CITY OF SOUTHGATE PLANNING COMMISSION AGENDA

1. Planned Development (PD) Site Plan Amendment, 15601 Northline

1. Conditional Use Review, 15446 Fort
2. Site Plan Review, 15446 Fort

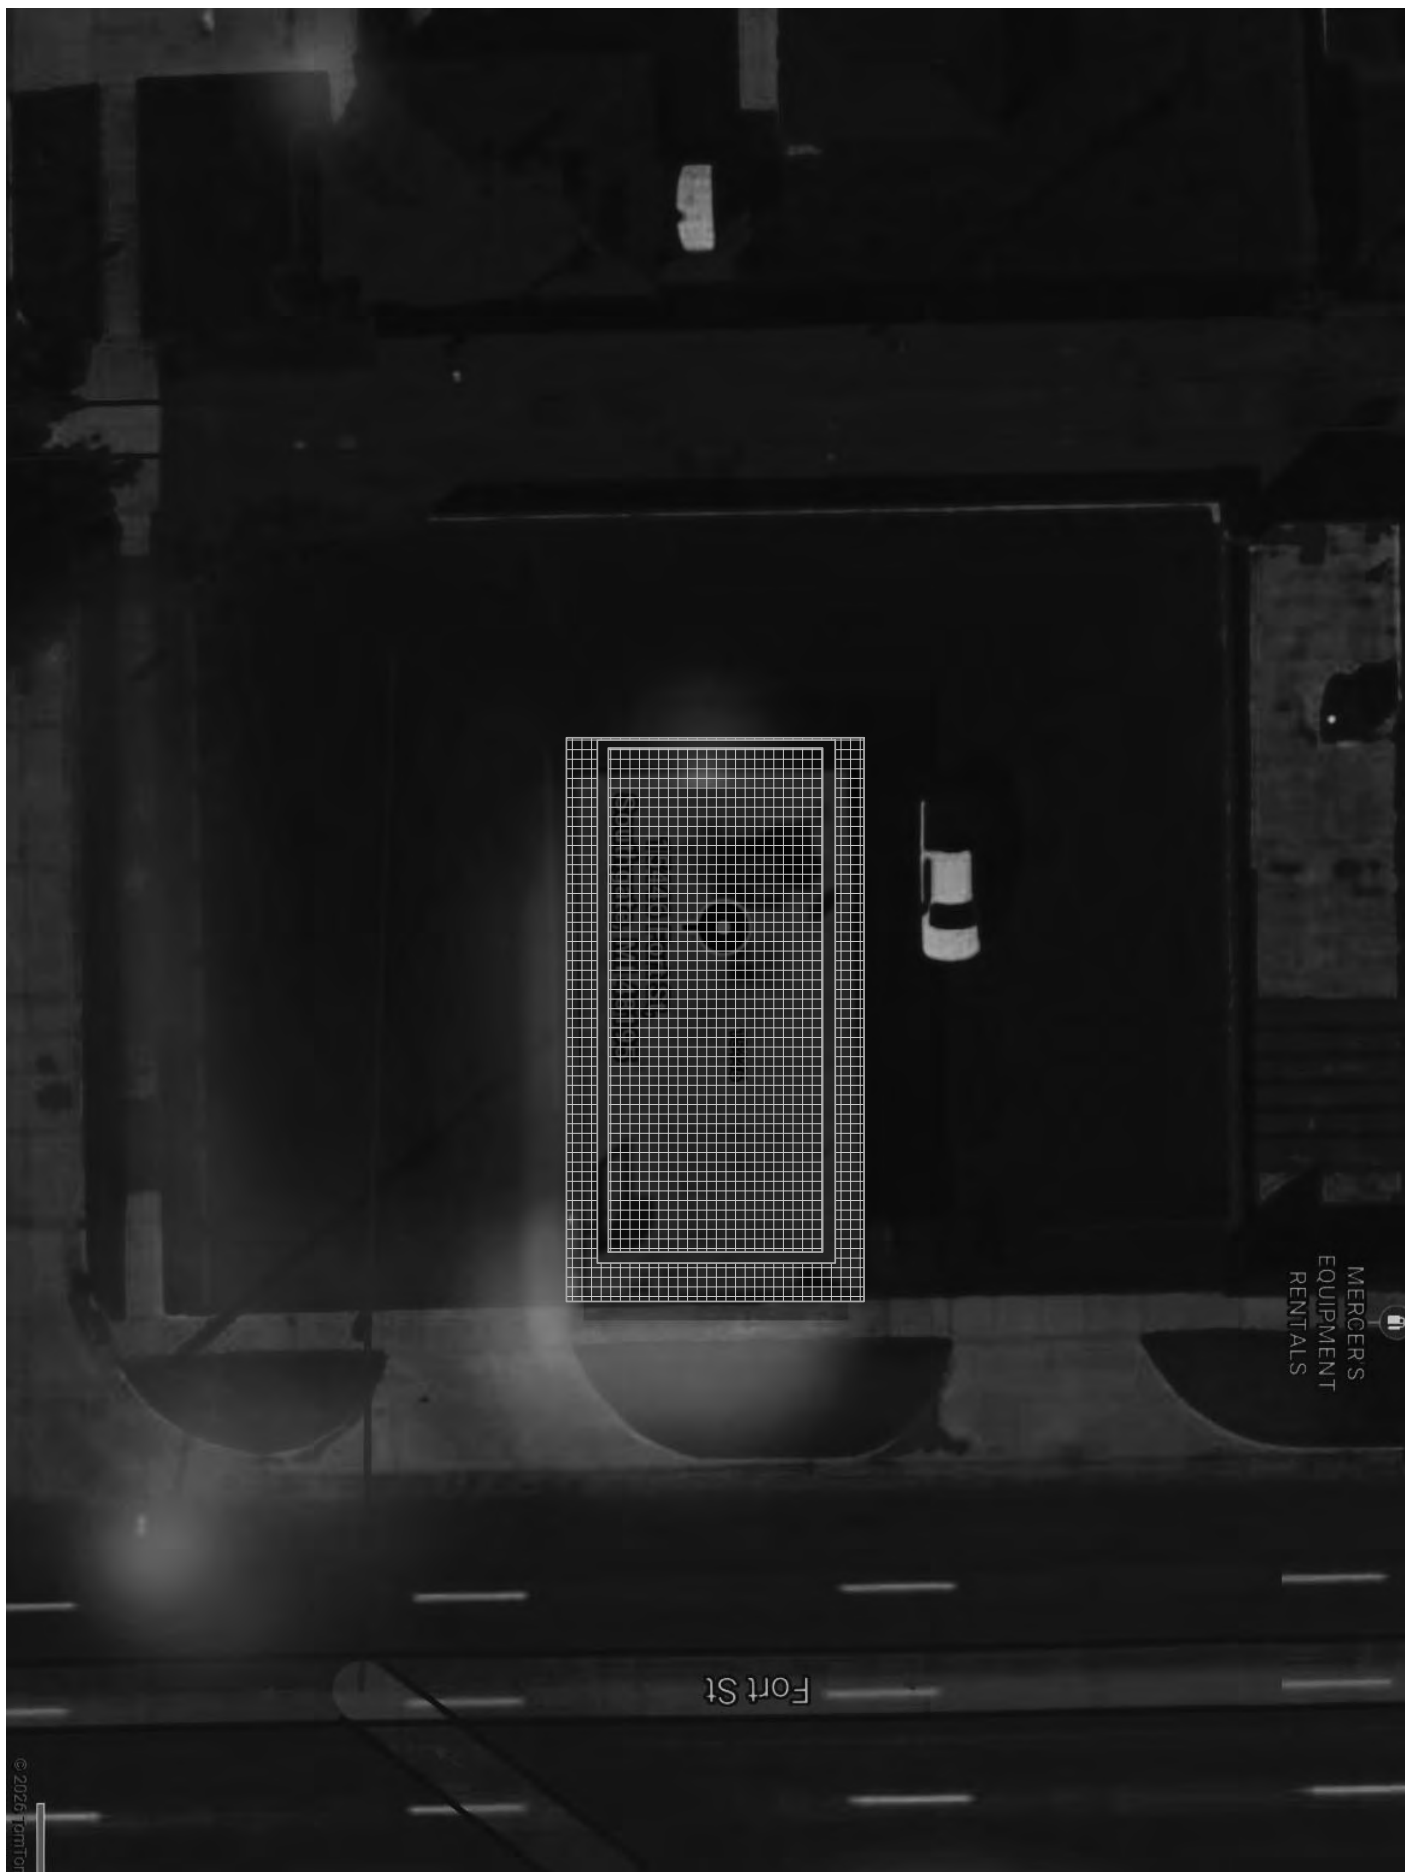
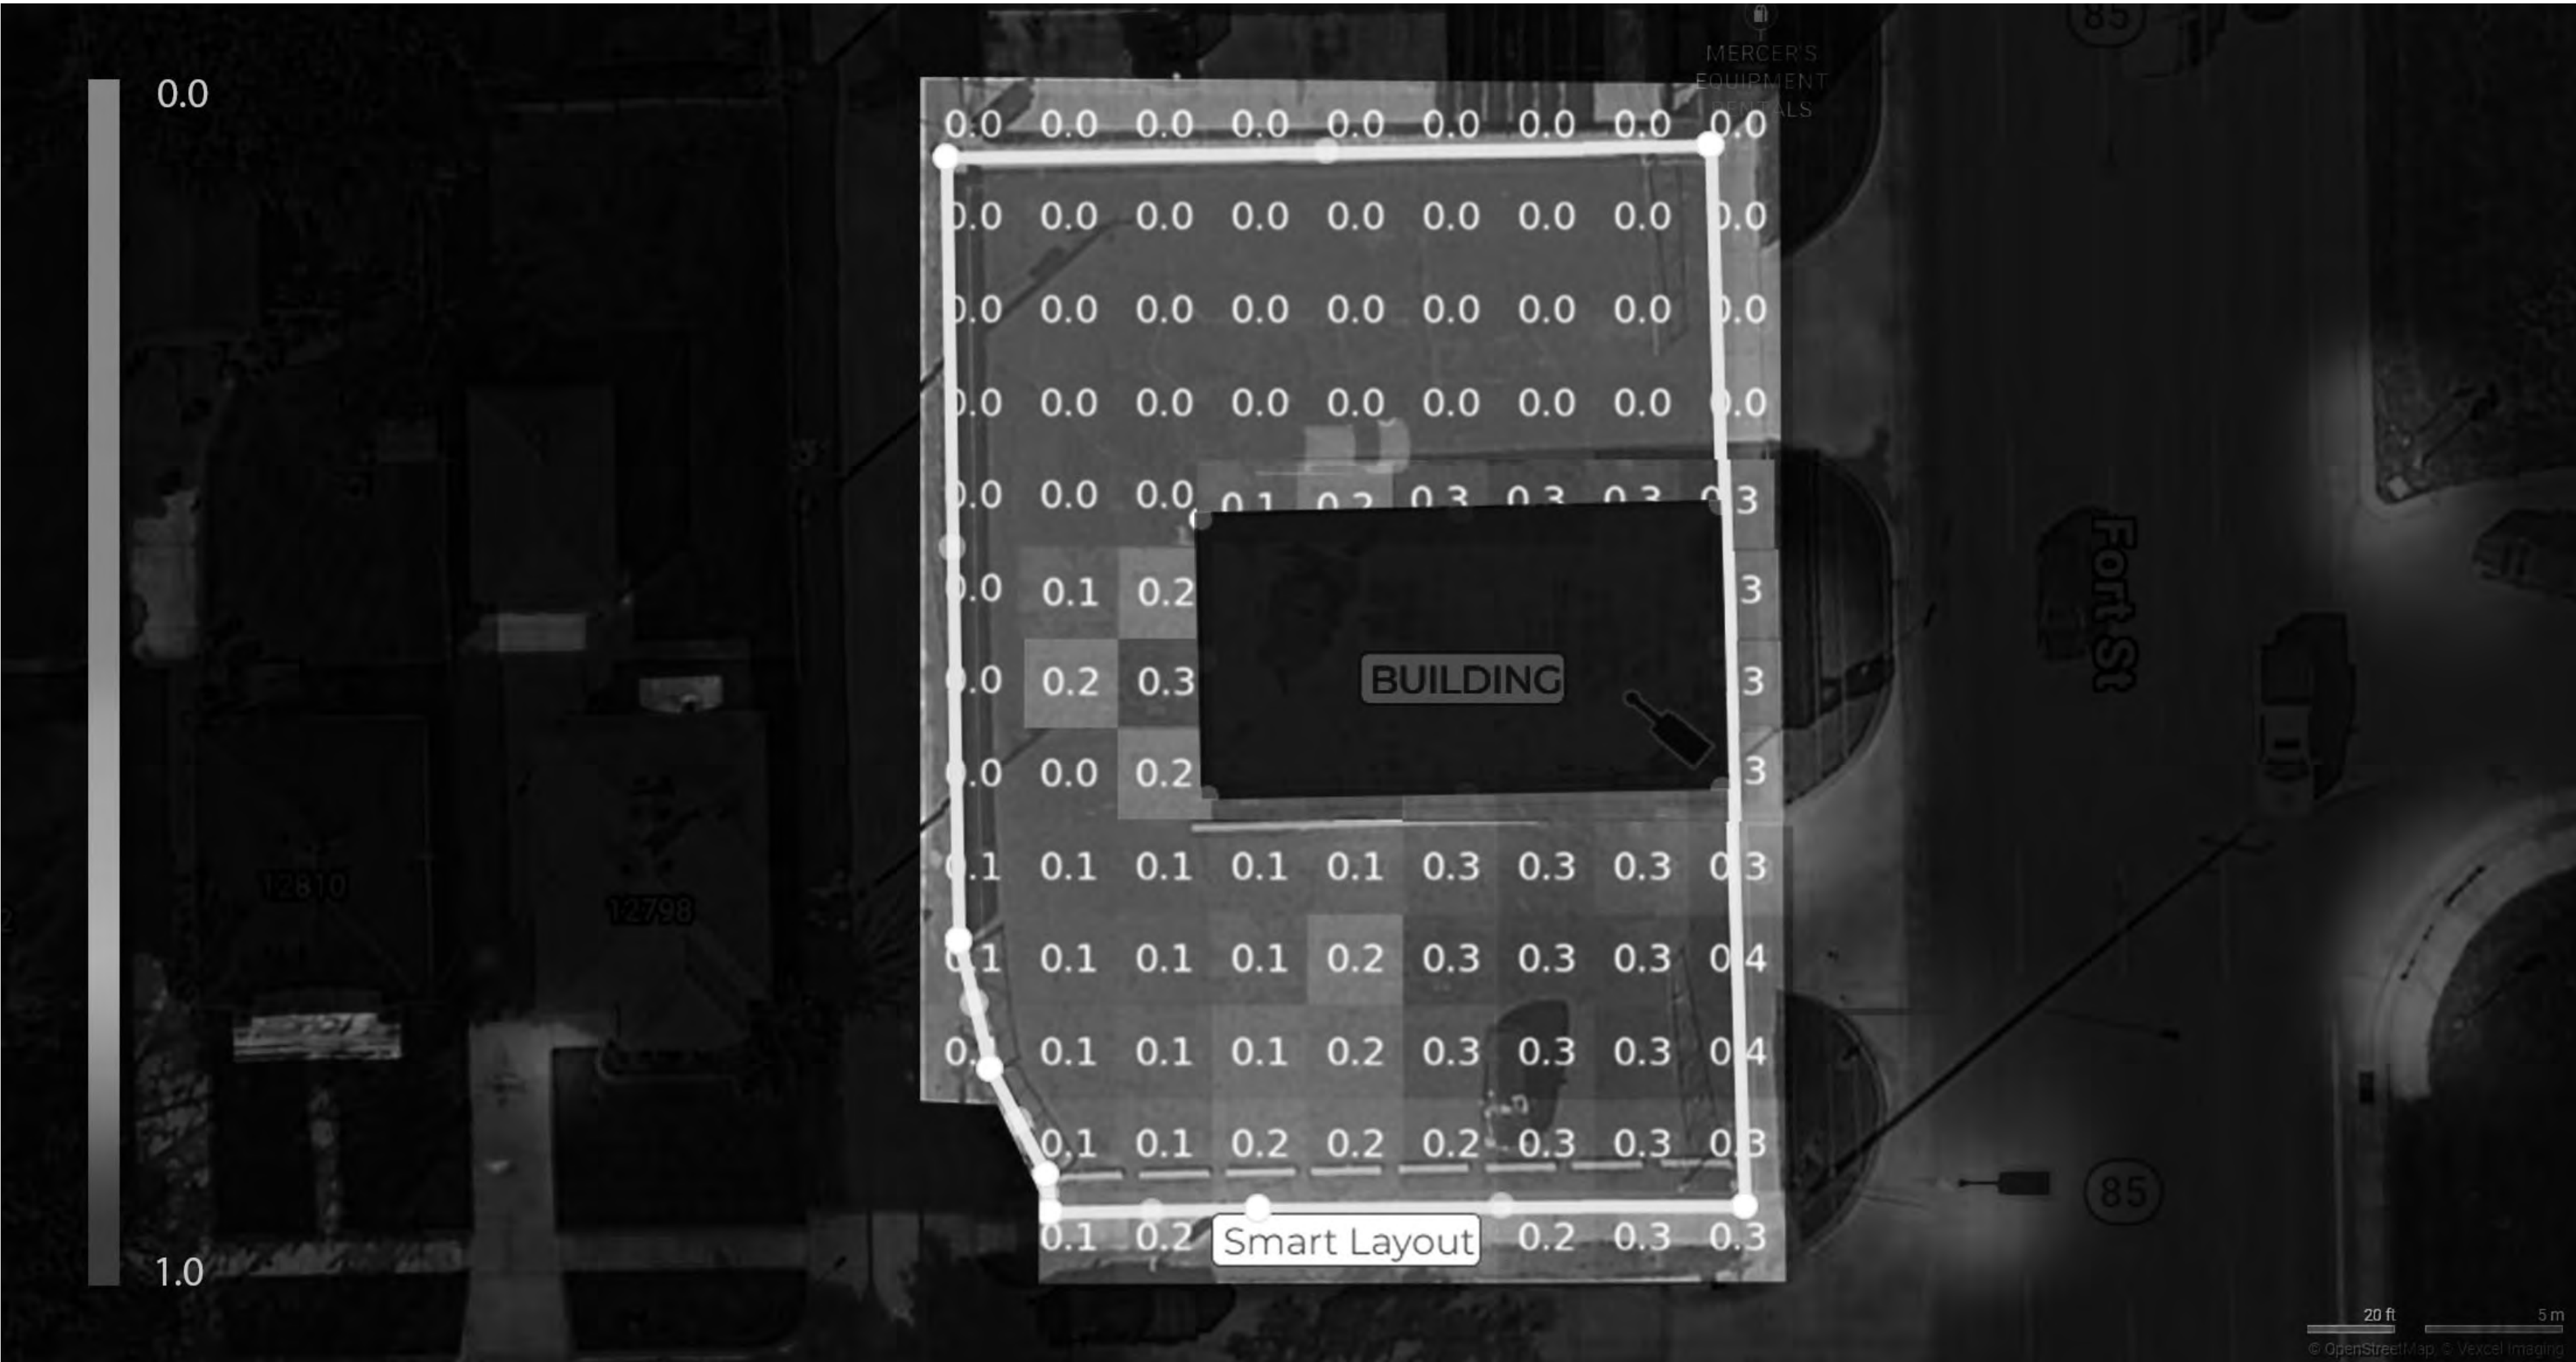
A lighting/photometric plan has been provided on sheet AS101. Footcandle measurements show 0.0-0.1 values at the north and west property lines, with 0.1-0.4 values on the south and east property lines. The applicant has indicated all existing lighting fixtures will remain as is.
